<b>High Level Review of the Mt Pleasant Operation Mine Optimisation Modification Environmental Assessment May 2017</b>	
<b>Date:</b>	2 July 2018
<b>To:</b>	The President of the Hunter Thoroughbred Breeders Association
<b>From:</b>	Rod Carr, Director at Marsden Jacob Associates

Marsden Jacob Associates, one of Australia's leading independent economic and financial advisory firms, has undertaken an expert review of the economic analysis of the Mt Pleasant Operation Mine Optimisation Modification Environmental Assessment.

Peter Stephenson, Managing Director of Stephenson Environmental Management Australia (SEMA) (CV attached as Appendix C) was requested by the Hunter Thoroughbred Breeders Association (HTBA) to undertake a review and critique of the air quality matters referred to in the assessment of the proposal conducted by the NSW Department of Planning and Environment in the Independent Planning Commission of New South Wales Proceedings No. D512/18 regarding the Mount Pleasant Operation Coal Mine Extension of Mine Life.

## **Review of the Mt Pleasant Operation MOD3 Mine Optimisation Modification**

MACH MOD3 EA Main Text Figure 10 p.25 showing the one big footprint fines rejects storage facility

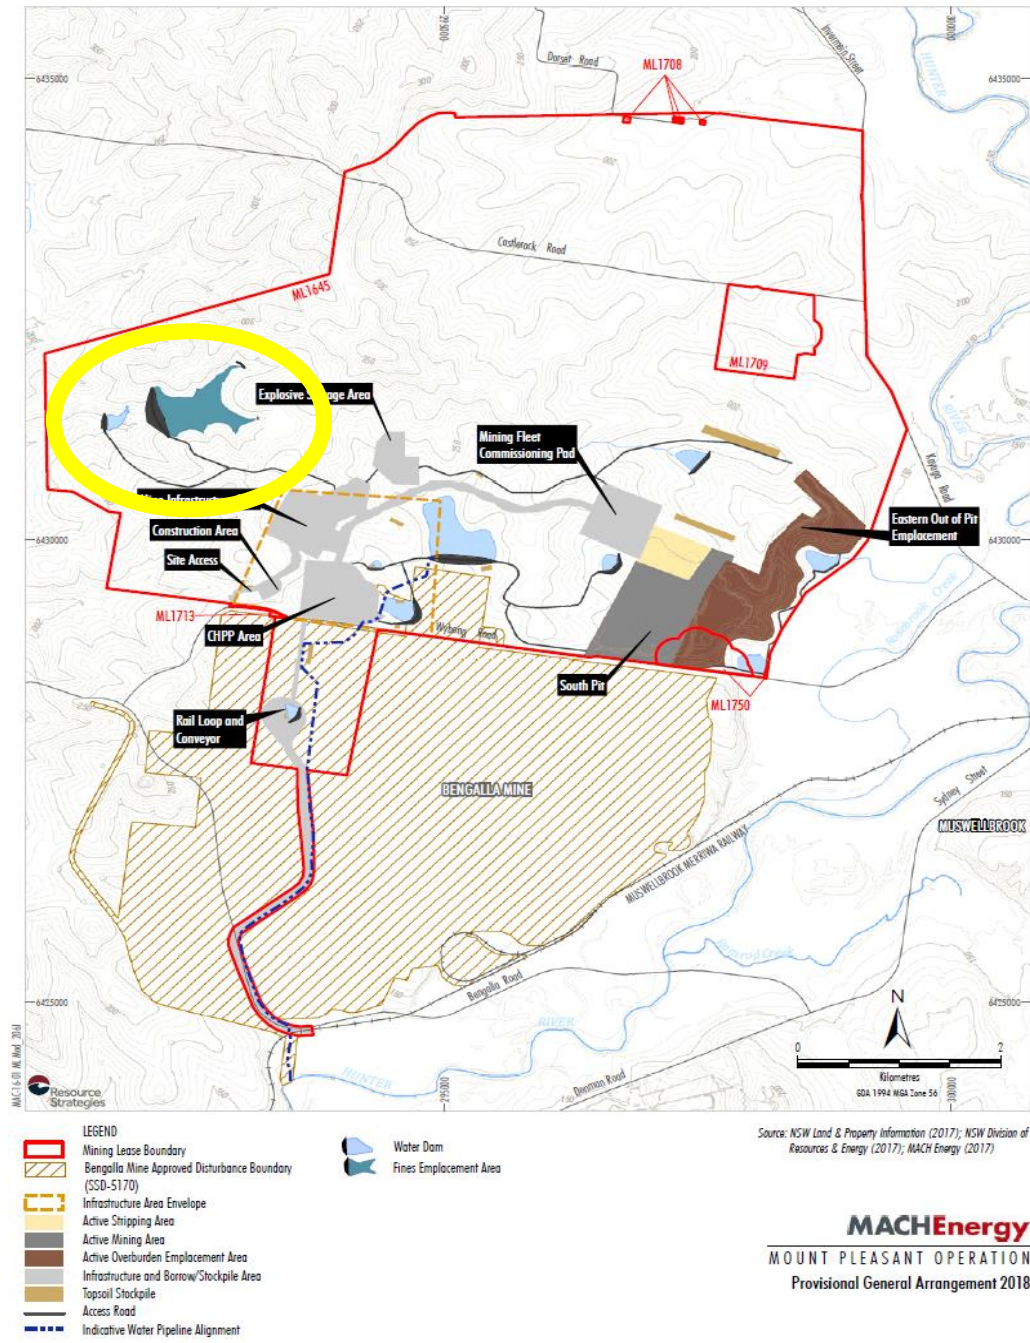
In MACH MOD 3 EA a significant change in operating strategy is proposed:

There have been no technical reasons provided in the MOD3 EA as to why the currently approved Operating Strategy cannot be executed. The reasons for this proposed change in operating strategy seem to be solely financial. The 1997 operating strategy would require more equipment and ongoing management effort than the MOD3 proposed operating strategy.

In my opinion it is clear that the 1997 fine tailings emplacement strategy containing multiple cells and offering earlier rehabilitation was specifically detailed and considered in the 1999 Approval process and does not allow discretionary, significant and poorer environmental outcome changes to be made by MACH Energy.

Figure 4. Viewshed analysis of proposed mining operations (2020)  
 Source: Mt Pleasant Project Landscape Management Plan, 2012

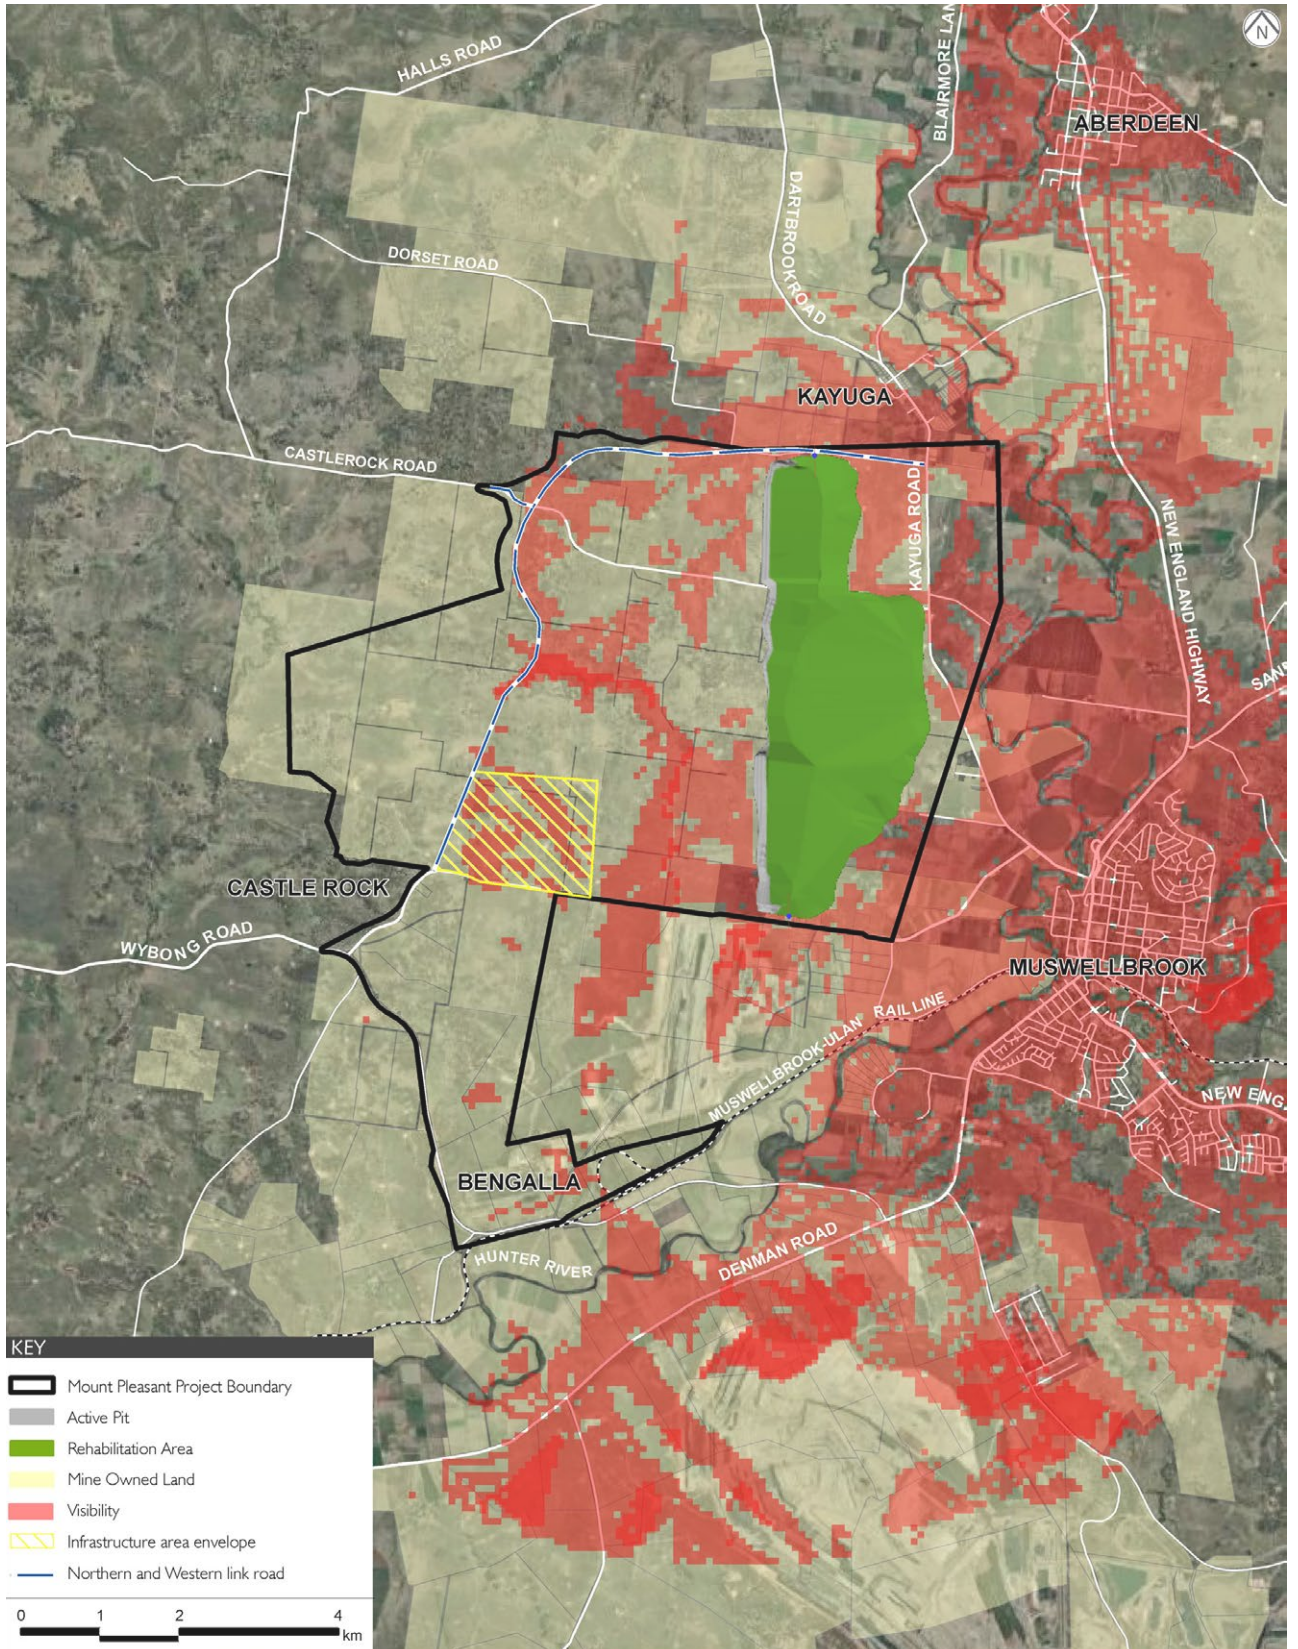
The Geoffrey Britton report (1997) identifies a number of viewpoints from sensitive receivers including Muswellbrook, Aberdeen and Wybong Road. A subsequent Landscape Management Plan (2012) prepared for Coal and Allied illustrates a viewshed analysis (Figure 4) of the locality that establishes the Mt Pleasant site as a prominent location within view from an extensive catchment including extensive areas of Muswellbrook and Aberdeen.

Figure 8. Viewpoint locations in Muswellbrook

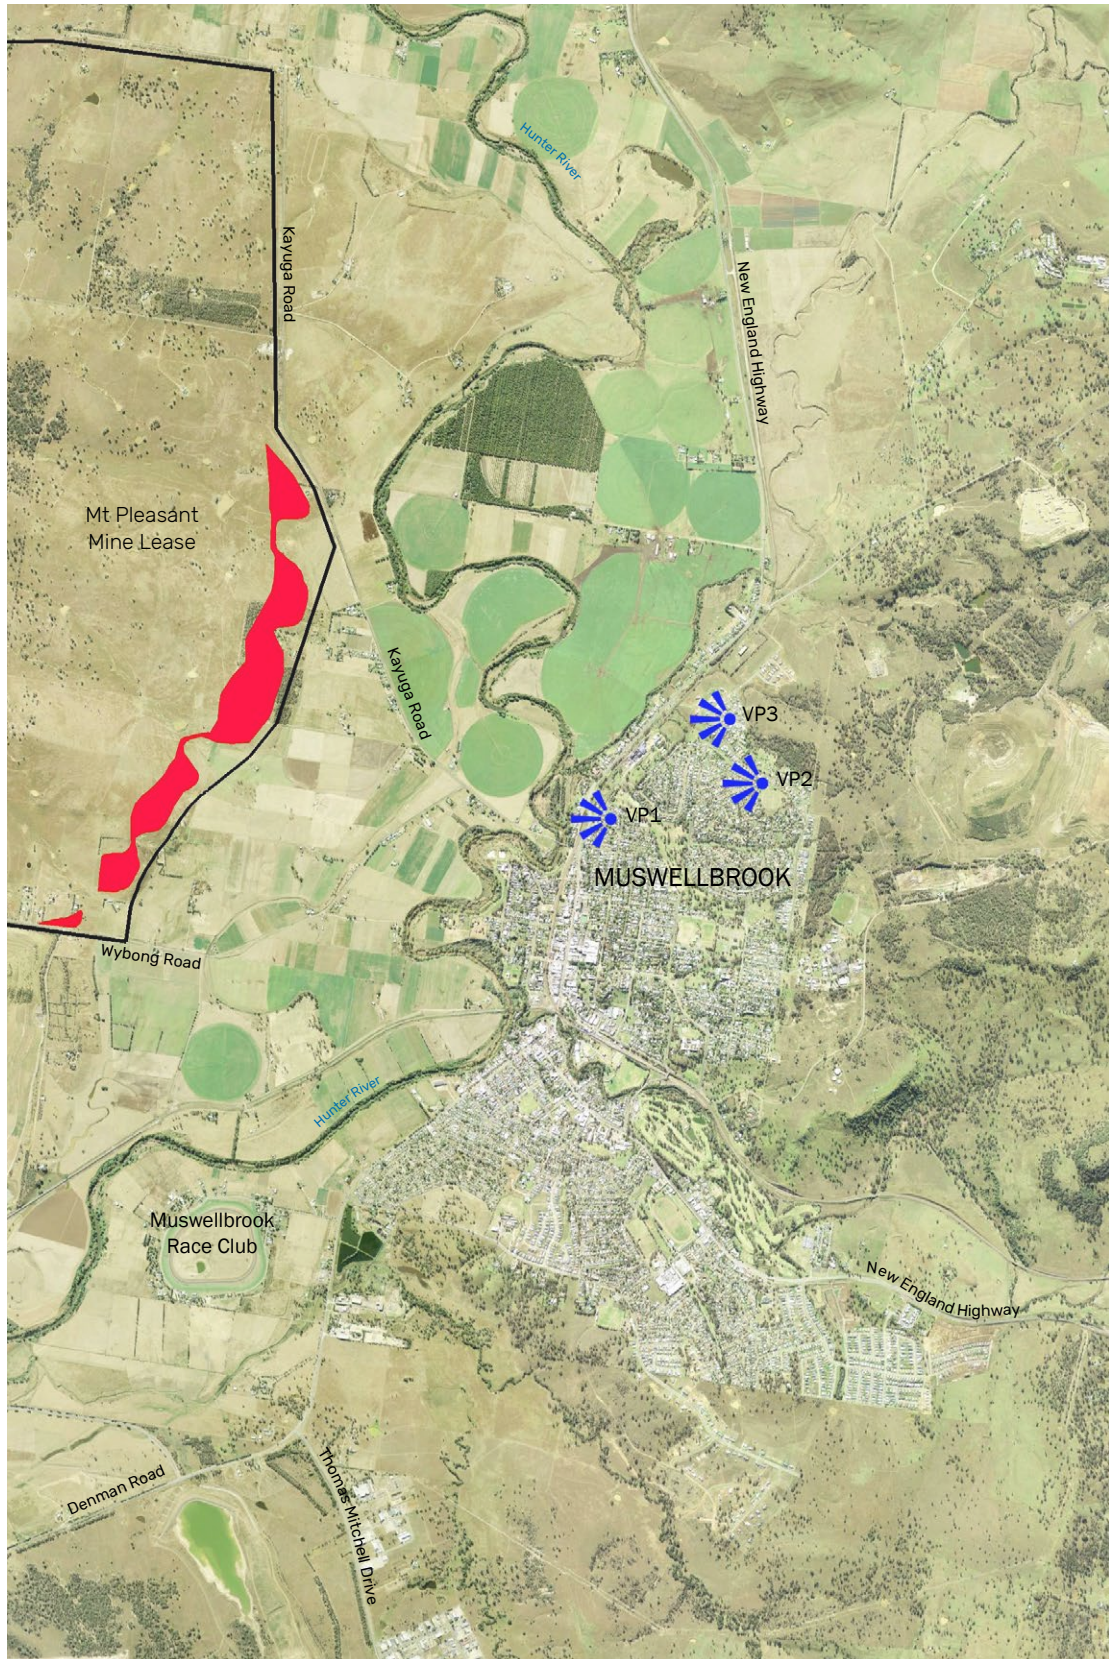
Figures 5, 6, and 7 illustrate the extent of views over the mine site from three locations in Muswellbrook and demonstrate the degree of exposure these and other similar locations would have to the proposed mine modification. These viewpoints and others, should have been acknowledged and assessed in the EA to more accurately show the level of visual impact that this modification would have on the residents and motorists in the area.

The EA report fails to identify all of the appropriate viewpoints from which the Modification would be visible. There are numerous viewpoints within the elevated urban areas of Muswellbrook as well as along local roads that should have been assessed (Refer Figures 4, 5, 6). One viewpoint cannot be used as representative viewpoint for an entire area. The lack of adequate numbers of viewpoints from sensitive receivers significantly affects the ability to thoroughly analyse the Modification and determine the true visual impacts.

The viewpoints chosen for the photomontages are not the most impacted viewpoints, for example VP1 in Figure 5 is an elevated view from the New England Highway which is above the EA Viewpoint 6, located on the railway line below. This highway viewpoint is more exposed and closer to the proposed modification than the EA's Viewpoint 5 on the New England Highway and should have been selected for assessment and a photomontage.

Figure 9. Light Pollution Levels in the Mt Pleasant region of the Upper Hunter

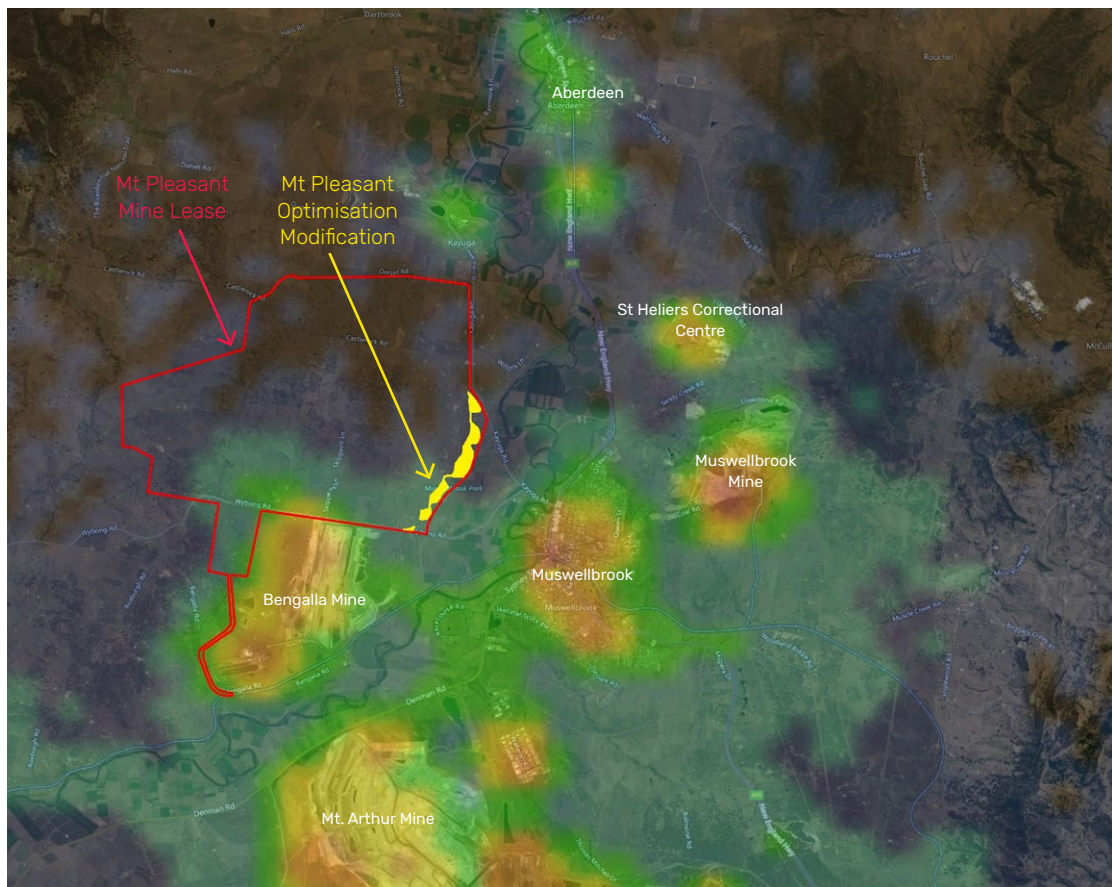
Light pollution is another significant and daily indirect visual impact that has not been considered by the report. Mining operations produce considerable levels of light that can in some instances equate to that of suburban and urban areas (Figure 9). The generated light pollution would affect the existing dark rural sky of the region. The exclusion of this impact along with other potential indirect impacts in the report are unacceptable and question the overall assessment of visual impact put forward within the report.
